**DA/1034/2013 - Supplementary Report No. 2 - Proposed Boarding House at
2-4 Glen Road, Ourimbah**

AUTHOR: Julie Garratley; Development Planner

Figure 2: Portion of floor plan showing the increased setback of 5m on the eastern side and the new location of the manager's residence.

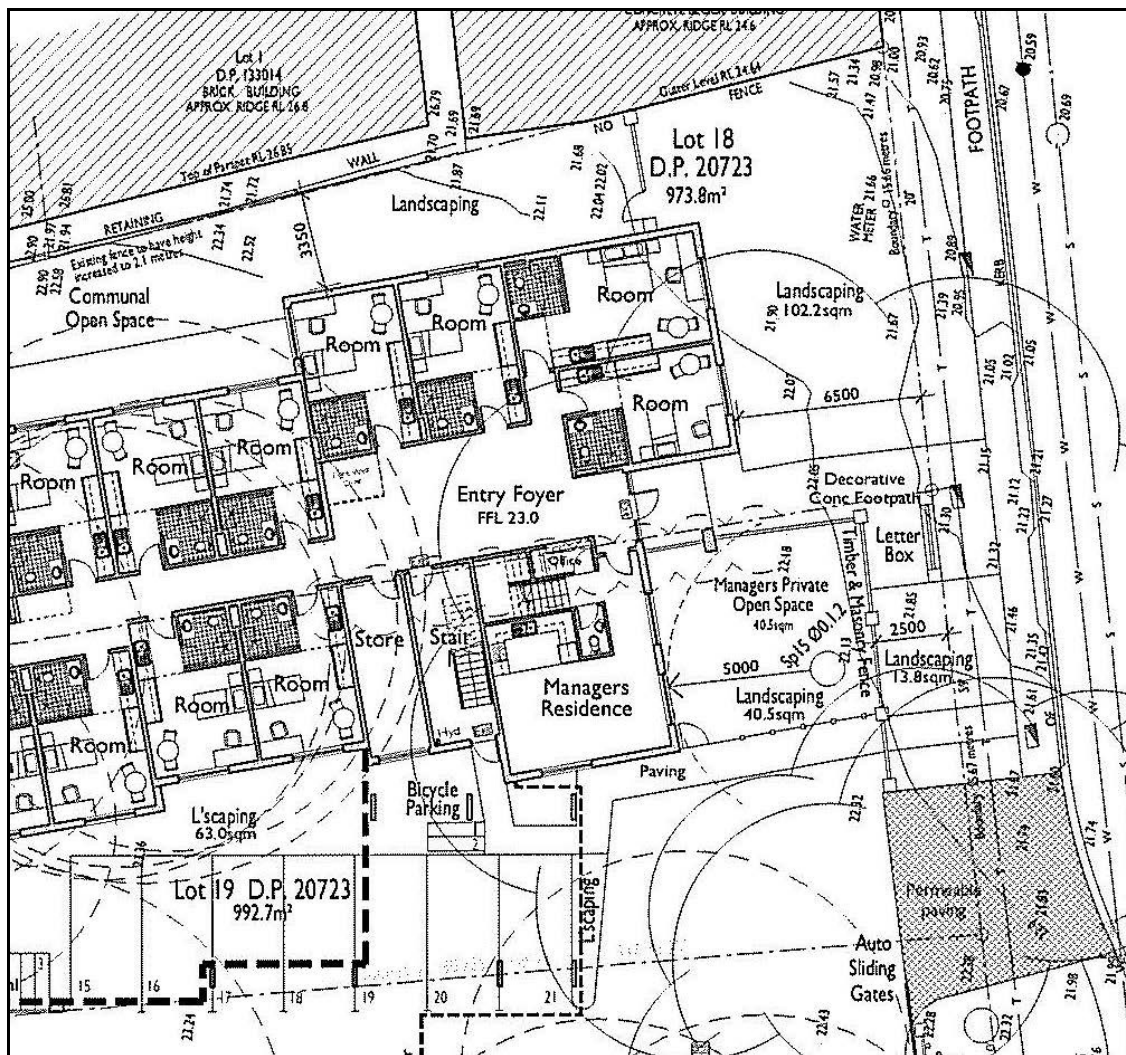
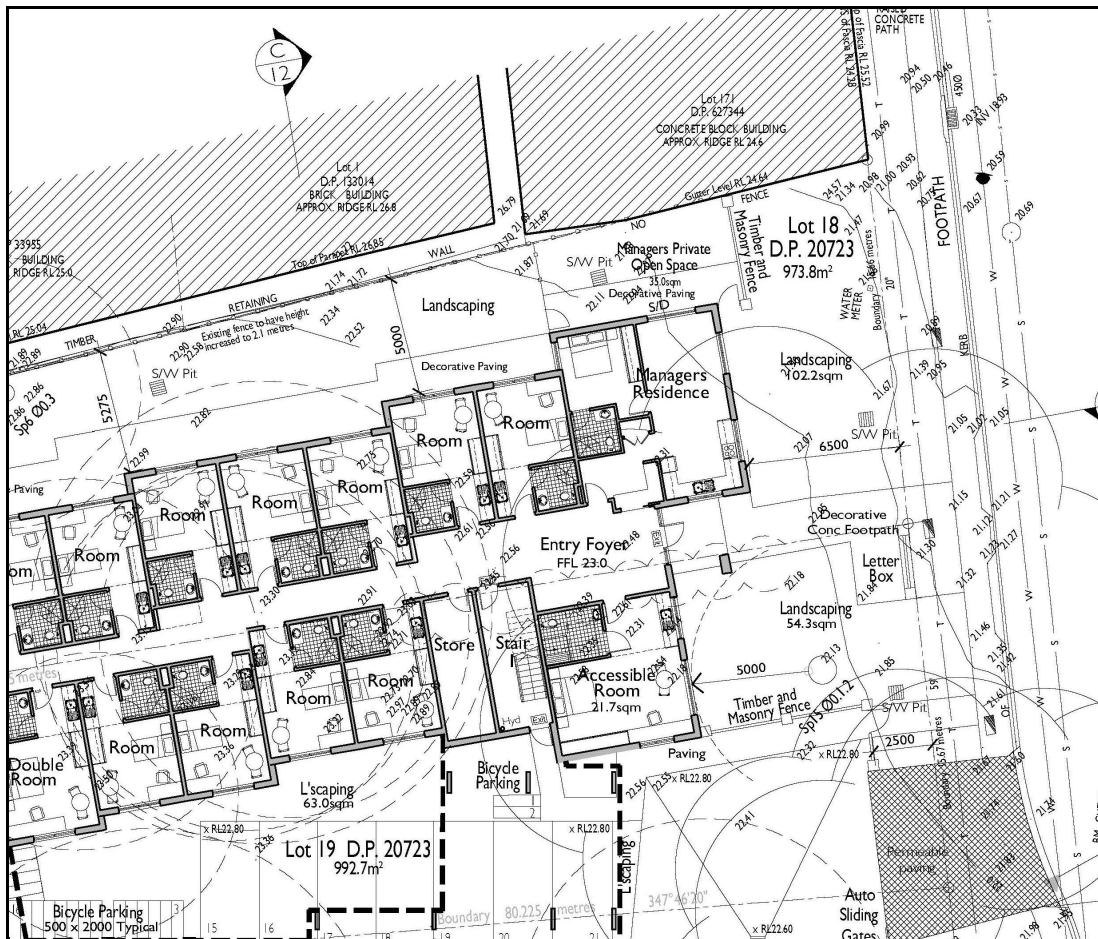
Consideration should be given to increasing the amenity of units 24, 25, 125, 126, 225 and 226 by increasing the setback from the eastern boundary.

Please see revised architectural plans showing the above mentioned units relocation slightly to the west increasing the setback to 5 metres from the eastern boundary. This has created a small step in the building, and therefore further articulation.

The setback distance to the eastern boundary has been increased to 5.0 metres adjacent to units 24, 25, 125, 126, 225 and 226. The manager's residence has been relocated from the left hand side of the front entry to the right hand side with an accessible room in its previous location. The relocation of the manager's residence also relocates the manager's private

The increase of the setback has resulted in further articulation providing an additional step in the eastern elevation of the building. The revised setbacks proposed for the eastern side of the development are considered reasonable and assist with increasing the amenity to those units adjacent to the eastern boundary.

The relocation of the manager's residence and manager's private open space has enabled the front of the building to address the street in a more positive manner by removing the courtyard fencing previously proposed. The Tallwood (Tree 1) that was previously located behind the courtyard fencing is now incorporated in the landscape design and retained as a feature of the streetscape.

Figure 3: Portion of floor plan showing the location of and access to the outdoor recreation area.

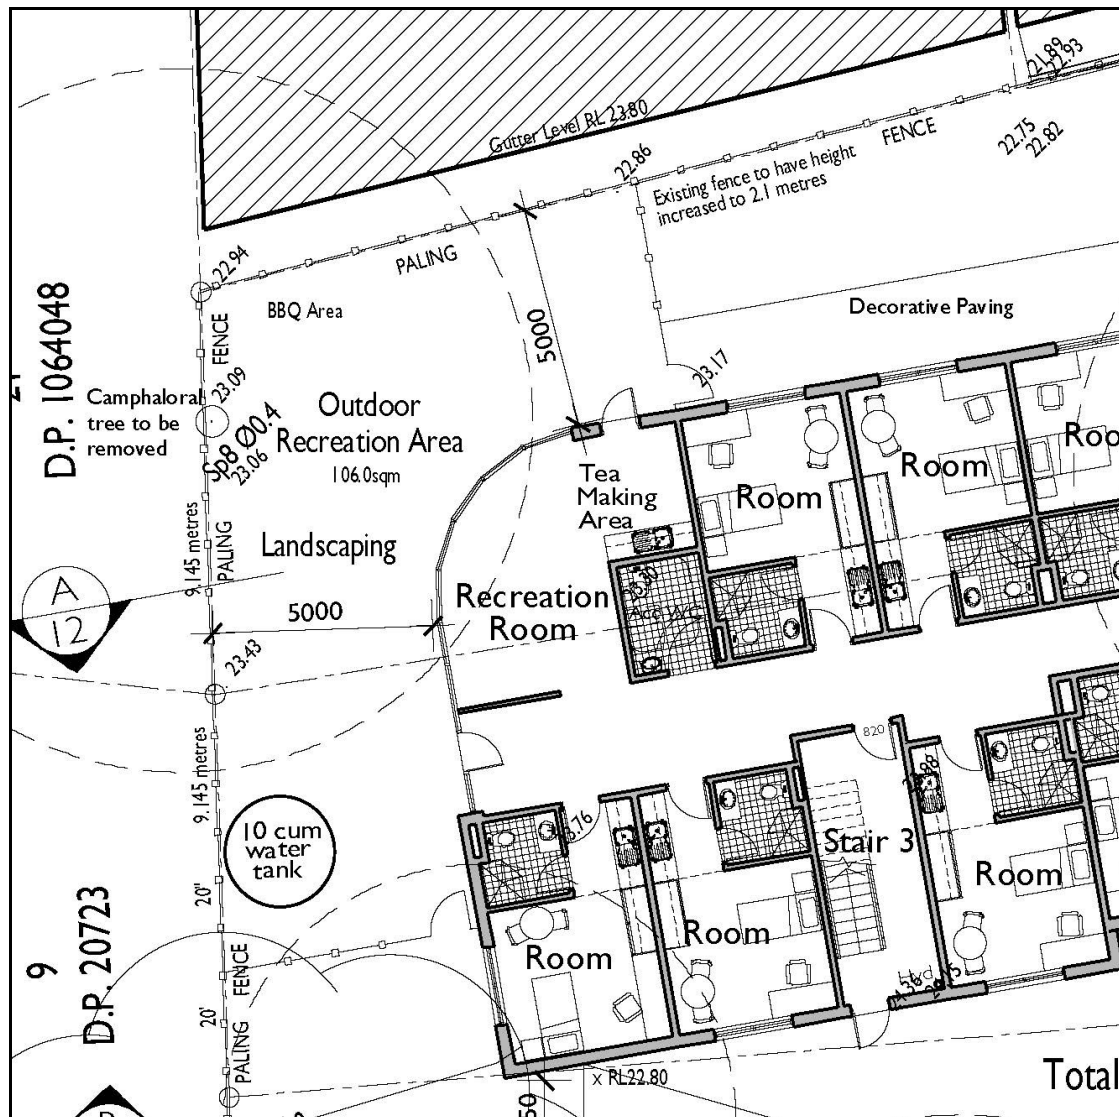
The common areas identified on the southern end of the building should be removed from the plans as per the recommendation within Council's assessment report.

The outdoor common area is now exclusively adjoining the ground floor recreation room. There is a total of 106m² of common area open space and the BBQ has been relocated to the north eastern corner.

The common areas previously proposed at the southern ends of each floor have been removed which will provide the occupants of the units in these areas with greater amenity and acoustic privacy.

The outdoor open space area previously located on the eastern side of the building has been relocated to the northern side of the building where optimum solar access can be achieved.

A total open space area of 106m² is accessed from two doors on the ground level, one on the northern elevation accessed from the end of the hallway adjacent to the recreation room and one on the eastern side which has direct access from the recreation room.
